SUBJECT: ISSUANCE OF AMENDMENT (TAC NO. M91160)

ATTACHMENT TO LICENSE AMENDMENT NOS. 64 AND 64

SAFETY EVALUATION BY THE OFFICE OF NUCLEAR REACTOR REGULATION  
RELATED TO AMENDMENT NO. 64 TO FACILITY OPERATING LICENSE NO. NPF-72  
AND AMENDMENT NO. 64 TO FACILITY OPERATING LICENSE NO. NPF-77

BRAIDWOOD STATION, UNIT NOS. 1 AND 2

FIGURE 3.4-4a  
 NOMINAL PORV PRESSURE RELIEF SETPOINT VERSUS  
 RCS TEMPERATURE FOR THE COLD OVERPRESSURE PROTECTION SYSTEM  
 APPLICABLE UP TO 16 EFPY (UNIT 1)

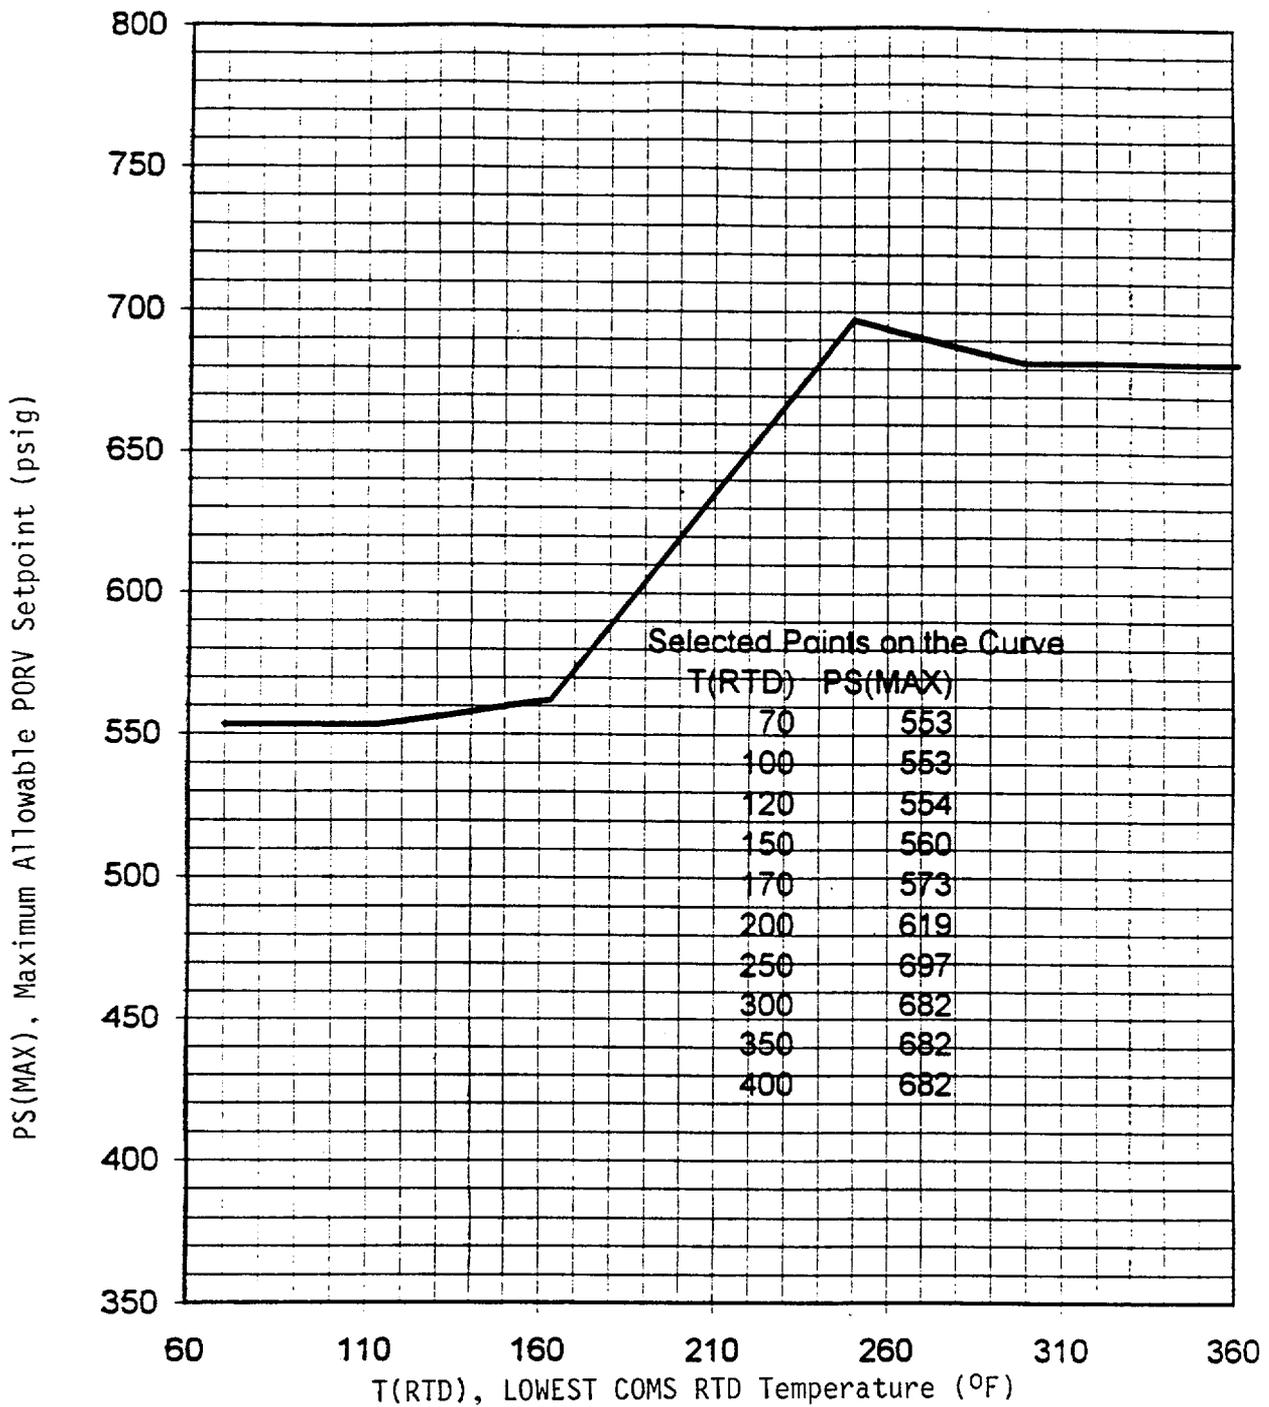
The amendments revise Figure 3.4-4a "Nominal PORV Pressure Relief Setpoint Versus RCS Temperature for the Cold Overpressure Protection (LTOP) System" in the Braidwood Unit 1's Technical Specifications (TS). The revision extends the applicability of Figure 3.4-4a from 5.37 effective full power years (EFPY) to 16 EFPY. In addition, the amendments remove the 638 psig administrative limit line from the LTOP curve, because the appropriate instrument uncertainties and discharge piping pressure limits have been incorporated in the new curve. Finally, the amendments contains administrative changes to Figure 3.4-4a and its associated index page.

By letter dated June 8, 1995, the licensee proposed a new TS Figure 3.4-4a which is applicable up to 16 EFPY. As the basis for generating the revised Figure 3.4-4a, a revised 10 CFR Part 50, Appendix G, P-T limit curve was

generated for 16 EFY. The licensee also applied for an exemption from the Appendix G requirement by using the ASME Code Case N-514 which allows the peak transient pressure to reach 10 percent above the Appendix G limit for the purpose of LTOP design. The methodology used to develop these new PORV setpoints is essentially same as that previously used for LTOP design at Braidwood plant. In response to the staff request, the proper instrumentation uncertainties have been factored in the setpoints study. A maximum PORV setpoint of 800 psig is used in the proposed Figure 3.4-4a for piping protection. In response to the staff request, the licensee indicated that its evaluation confirms that a PORV setpoint of 800 psig will provide adequate protection to the PORV discharge piping. The licensee has provided a tabulation of data from the results of its analysis for the staff review. These data indicate that at various RCS temperature conditions, the peak transient pressures will not exceed the P-T limits established by: 1) the Appendix G curve applicable up to 16 EFY in combination with the provisions provided in ASME Code Case N-514, and 2) the pressure limit to protect the PORV discharge piping.

The licensee's proposed changes in TS Figure 3.4-4a reflect the changes discussed above. The staff has reviewed the licensee's submittal and finds that the changes are based on the applicable regulatory guidance in SRP 5.2.2 (Revision 2), are reasonably conservative, and are acceptable.
